PCN (Product Change Notice)

PCN Number: PCN_UtRJ45LAN_20260717 Affected Series: WE-RJ45LAN Affected Part Number: see table "PART NUMBER, REVISION & DATASHEET" PCN Date: 2026-04-17 (YYYY-MM-DD) Effective Date: 2026-07-17 (YYYY-MM-DD)	Change Category: ☐ Equipment/Location ☐ General Data ☐ Material ☒ Process ☒ Product Design ☐ Shipping/Packaging ☐ Supplier ☐ Software
Contact: Product Management Phone: +49 (0) 7942 - 945 5001 Fax: +49 (0) 7942 - 945 5179 E-Mail: pcn.eisos@we-online.com	Datasheet Change: ☒ Yes ☐ No Attachment: ☐ Yes ☒ No

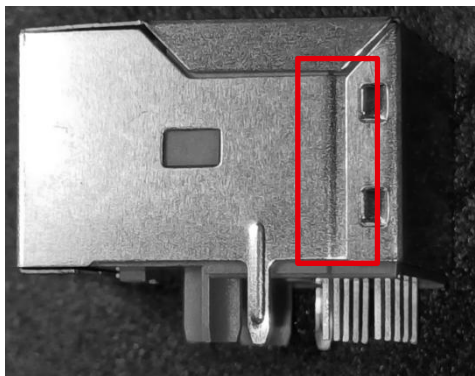
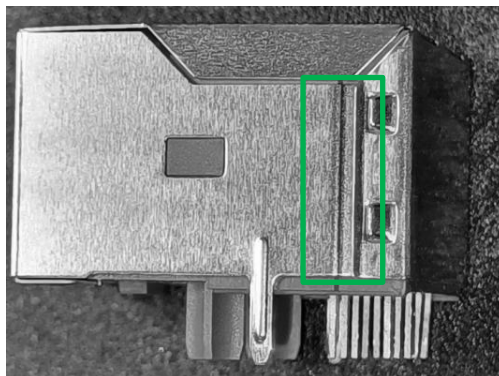
Due to an improvement of the production capability, Würth Elektronik eiSos will add a flanging to the shielding. There will be no change in fit, function, quality or reliability of the product.

before change	after change
Flanging is added to the buckle of the back
